MEMORANDUM

B1 - MEANS OF ESCAPE OBSERVATIONS

PREMISES: Grenfell Tower, Grenfell Road
APP No: Submission 1
SUBMISSION No: S1
DRAWING No: 1279(08) 101 01 BS, 100 01 BS.

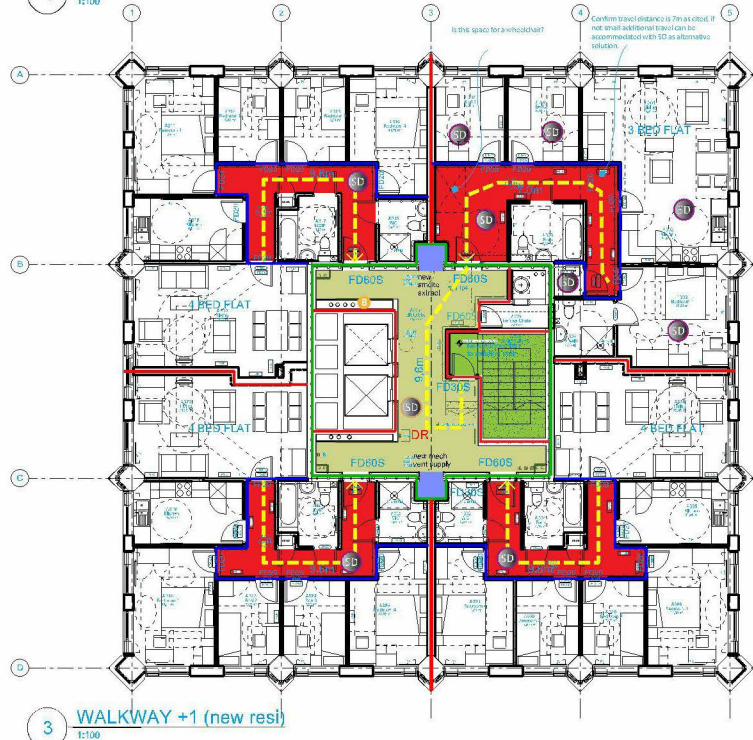
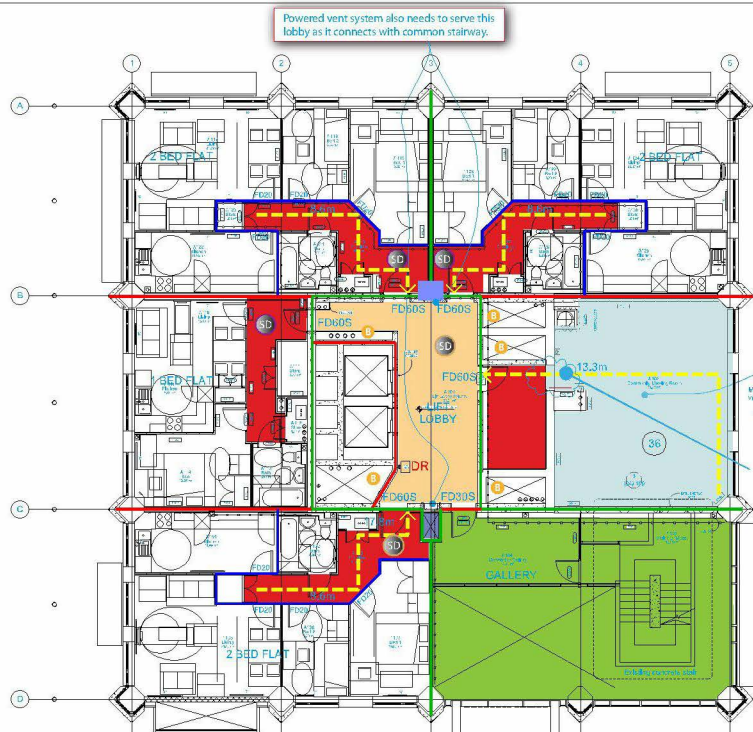
Residential flat opens directly into stairway without common ventilated lobby provided on other floors.

A suggestion based upon proposed layout is shown, by providing a screen and door to separate the stairway from the lobby. Note the powered vent shafts need to be brought down to serve the orange lobby.
